# SERVICE BULLETIN

PURPOSE : CORRECTION	ISSUE NO. : MSB-11E42-501	DATE : 2011-06-20
SUBJECT : DOOR-SIDE DOOR HINGE MOUNTING BOLTS TIGHTENING TORQUES		<MODEL> (EUR) 11-12 i-MiEV (HA3W)
GROUP : BODY

Tightening torques for the door-side door hinge mounting bolts have been incompletely specified in the applicable Workshop Manuals. This Service Bulletin contains the corrected descriptions.

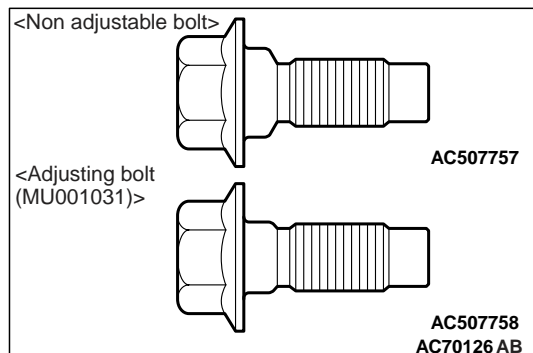
- Loosen the door-side hinge mounting bolts.
- Move the door to adjust so that the door is flush with the vehicle body.

- If adjustment is not possible, replace the door-side door hinge mounting bolt with the adjustment bolt (MU001031).  
*NOTE: If the adjustment bolt has been already installed, reuse it.*
- Move the door to adjust so that the door is flush with the vehicle body.
- Tighten the door-side hinge mounting bolts to the specified torque. ~~Deleted~~

~~Tightening torque <excluding two-tone paint>: 25±7 N·m~~

~~Tightening torque <excluding two-tone paint>: 35±5 N·m~~

Bolt	Paint	Torque
<p data-bbox="177 255 437 286">Non adjustable bolt</p> 	With	$25 \pm 7 \text{ N}\cdot\text{m}$
	Without	$35 \pm 5 \text{ N}\cdot\text{m}$
<p data-bbox="177 492 528 524">Adjusting bolt (MU001031)</p> 	Without	$35 \pm 5 \text{ N}\cdot\text{m}$

DOOR ASSEMBLY

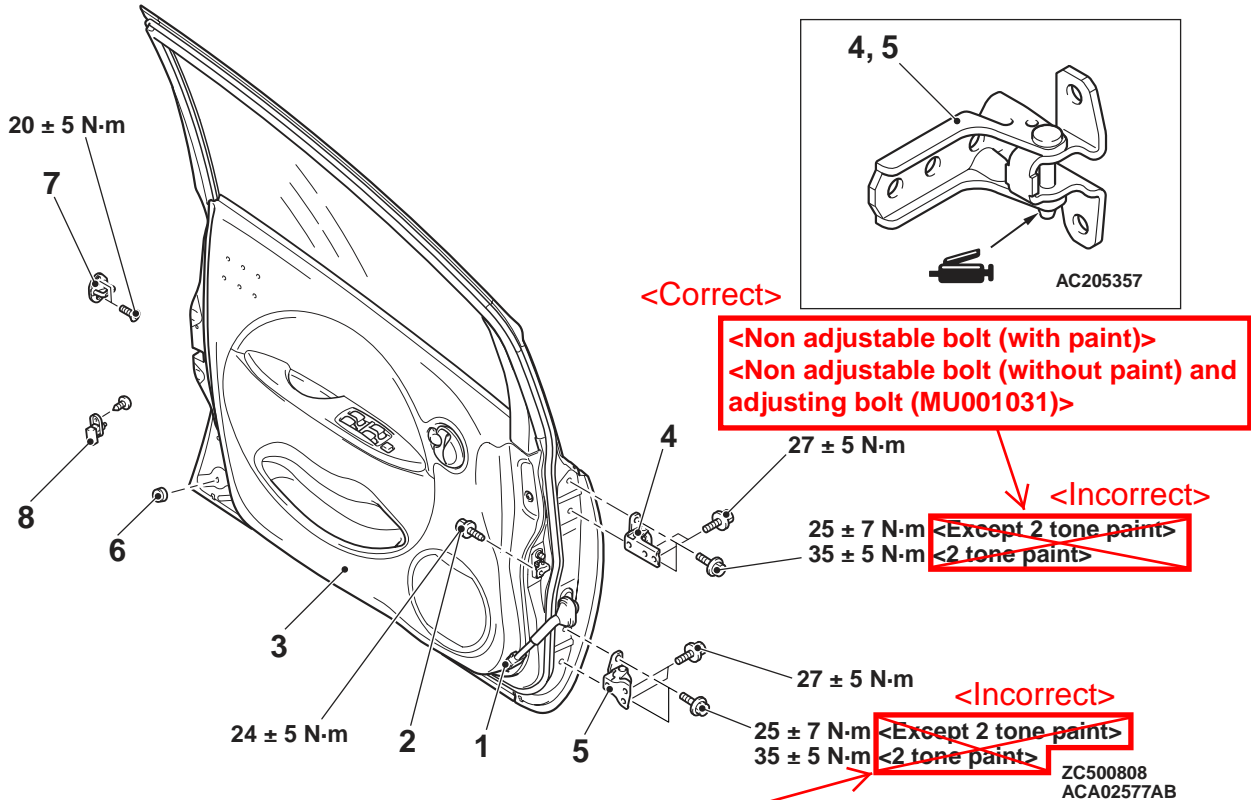
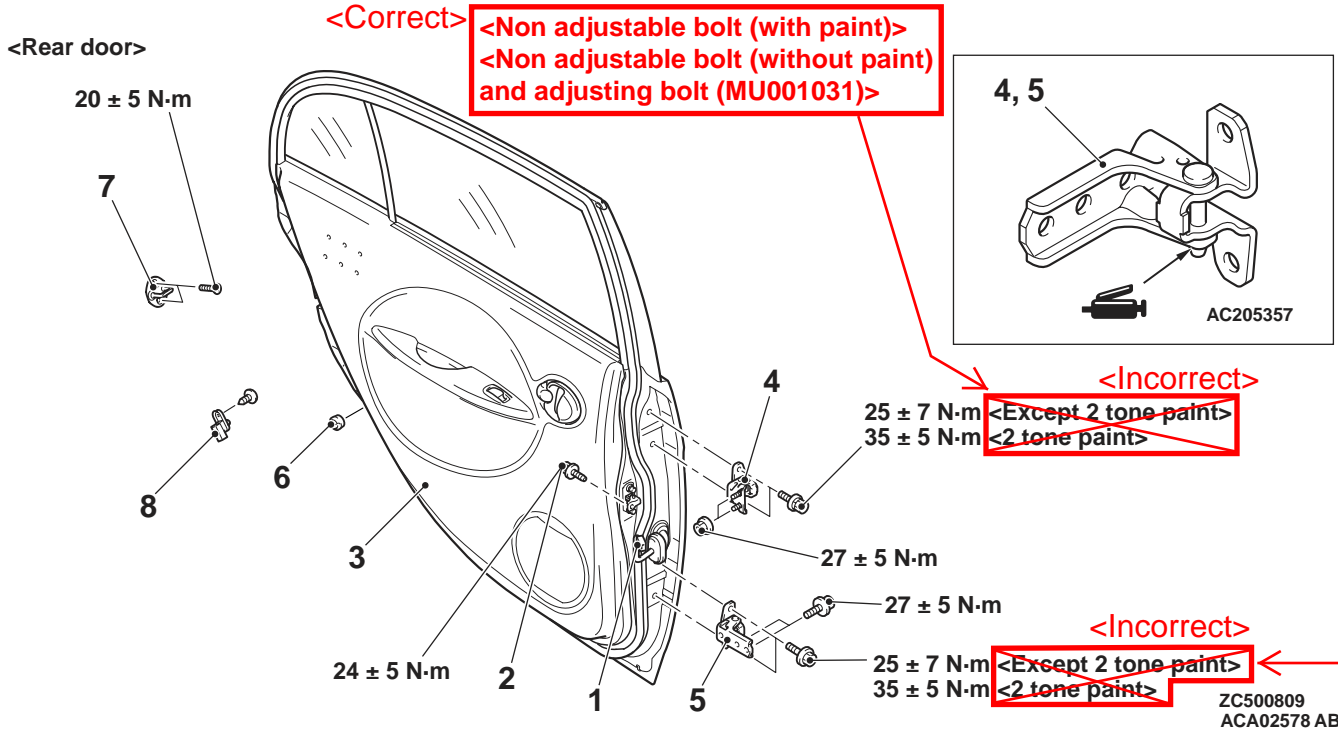
<Correct>  
<Non adjustable bolt (with paint)>  
<Non adjustable bolt (without paint) and adjusting bolt (MU001031)>

**>>A<< STRIKER INSTALLATION**

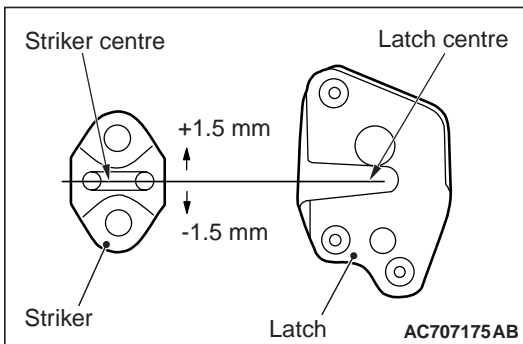
<Correct>

<Non adjustable bolt (with paint)>  
<Non adjustable bolt (without paint)>  
and adjusting bolt (MU001031)>
